10/715,046

Amdt. dated December 20, 2004

Reply to Office Action of Sep. 22, 2004

Amendments to the Drawings:

Reply to Office Action of Sep. 22, 2004

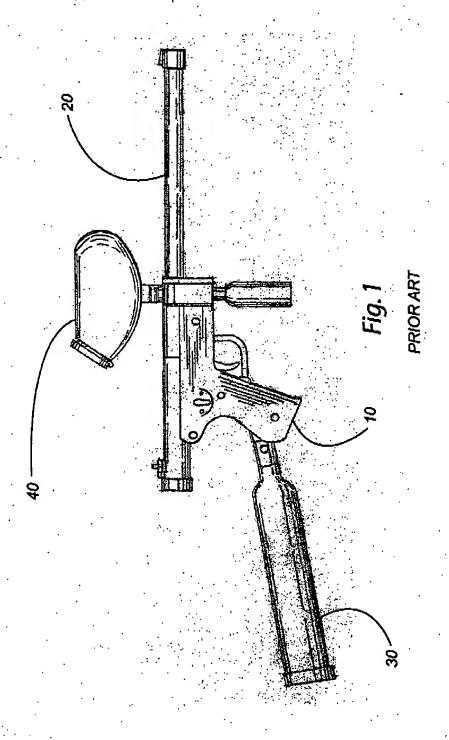
The attached new Sheet 5 of drawings includes only Fig. 5. This sheet which includes only Fig. 5, illustrates "second chamber which is separable from the first chamber" where rear chamber 70

is said second chamber.

New Sheet 5

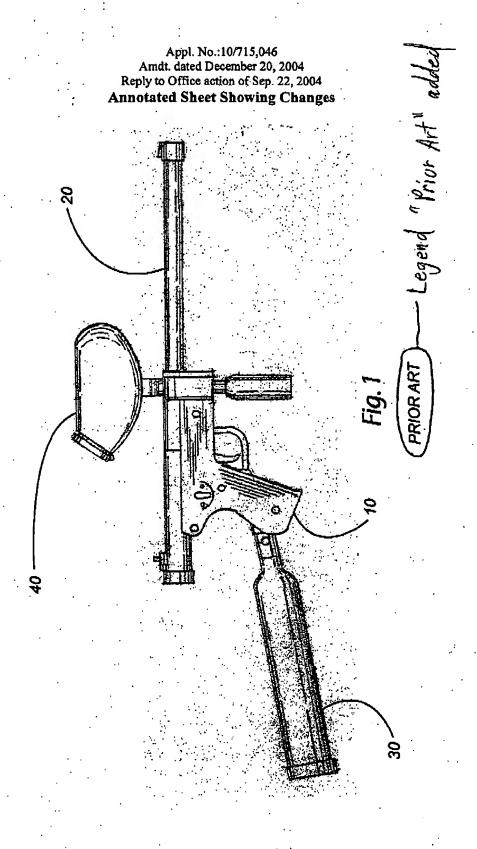
The attached new Sheet 6 of drawings includes only Fig. 6. This sheet which includes only Fig.

6, illustrates "first hopper having an upper portion and lower portion" the lower portion being

element 130.

New Sheet 6

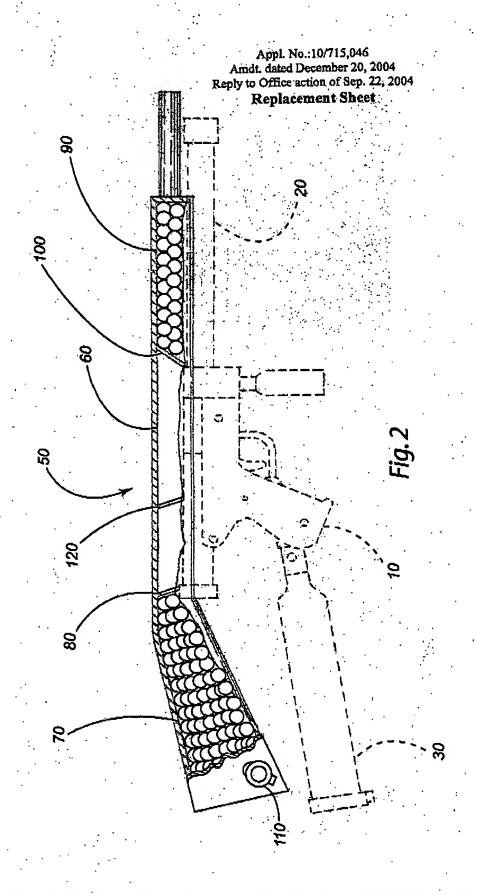
The attached new Sheet 7 of drawings includes only Fig. 7. This sheet which includes only Fig.

7, illustrates the magazine assembly separated from a paintball gun with an additional fill port

140 shown directly in central chamber 60.

Appl. No.:10/715,046
Amdt. dated December 20, 2004
Reply to Office action of Sep. 22, 2004
Replacement Sheet

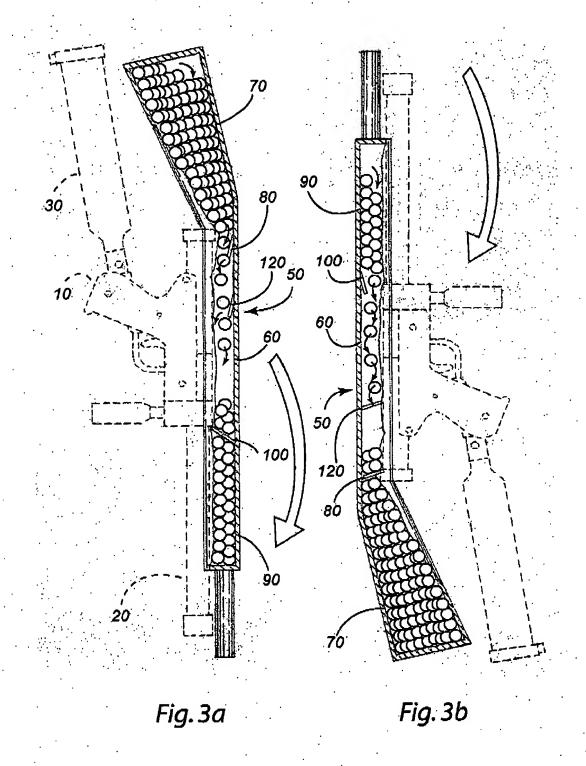
The attached Sheet 1 of drawings includes changes to Fig. 1. This sheet which includes only Fig.

1, replaces the original sheet including Fig. 1. In Figure 1, previously omitted legend "PRIOR

ART" has been added.

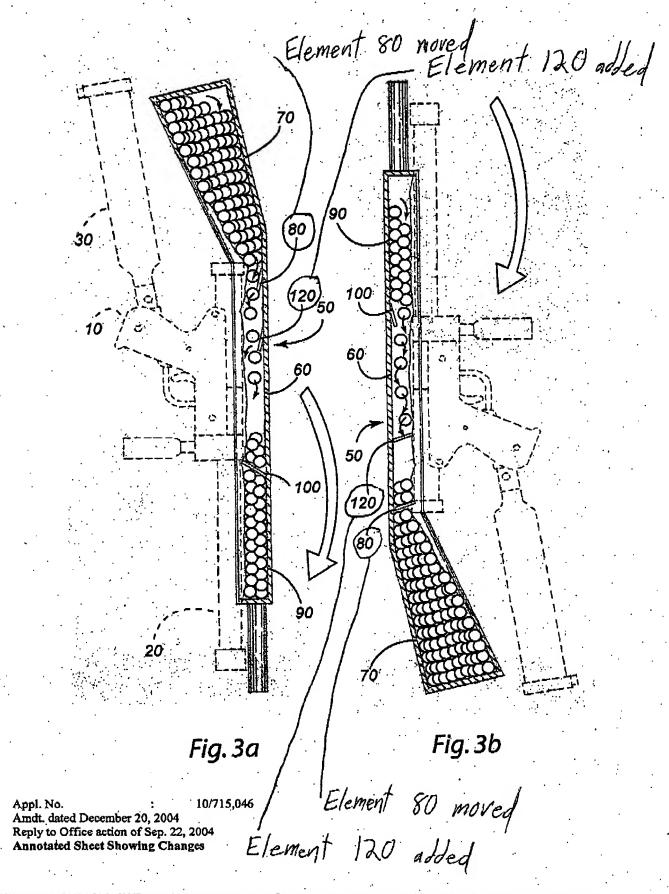
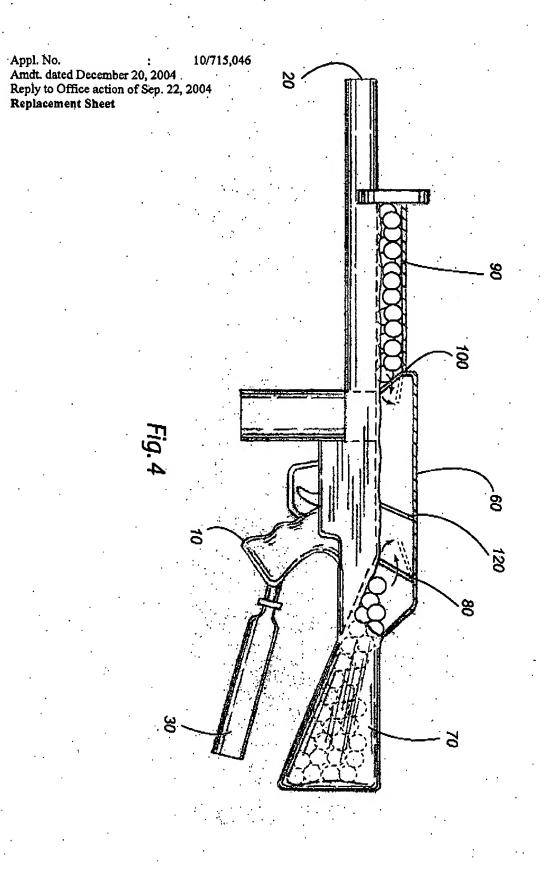
The attached Sheet 2 of drawings includes changes to Fig. 2. This sheet which includes only Fig.

2, replaces the original sheet including Fig. 2. In Figure 2, previously omitted elements 110 and

120 have been added. A partial covering of the cutaway of rear chamber 70 was added to more

clearly show element 110. Element 80 was moved rearward in central chamber 60 to make room

for added element 120.

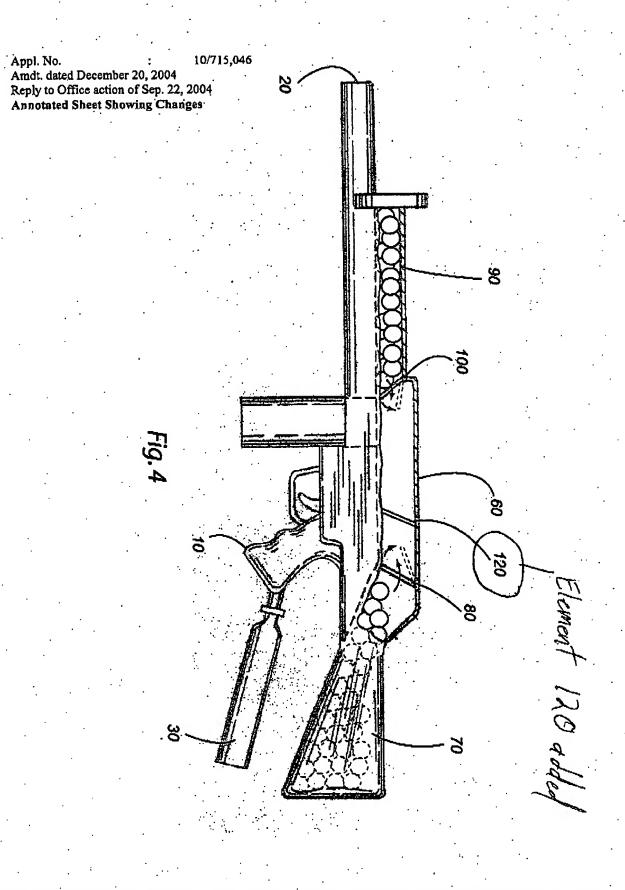
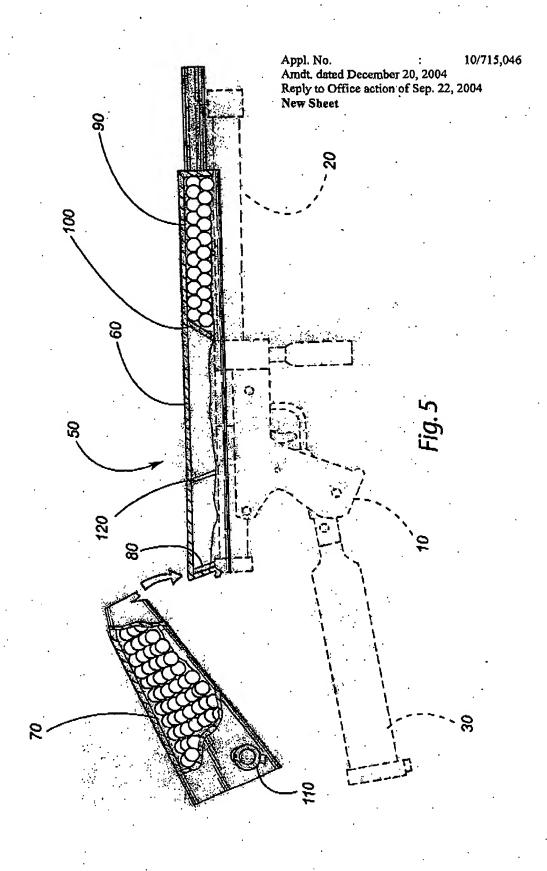
The attached Sheet 3 of drawings includes changes to Fig. 3a and Fig. 3b. This sheet which

includes Fig. 3a-3b, replaces the original sheet including Fig. 3a-3b. In Figure 3a, previously

omitted element 120 has been added. In Figure 3b, previously omitted element 120 has been

added. In both Fig 3a and Fig. 3b, element 80 was moved to rear of central chamber 60.

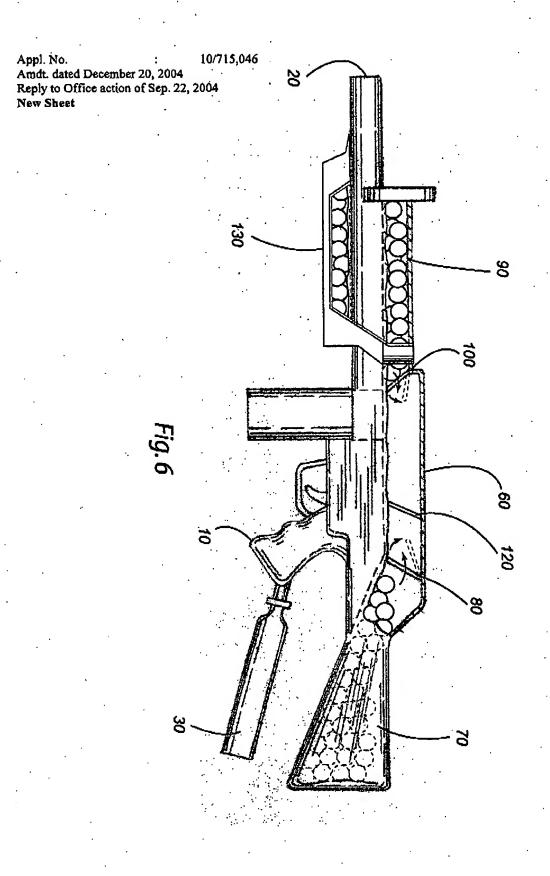
The attached Sheet 4 of drawings includes changes to Fig. 4. This sheet which includes only Fig.

4, replaces the original sheet including Fig. 4. In Figure 4, previously omitted element 120 has

been added.
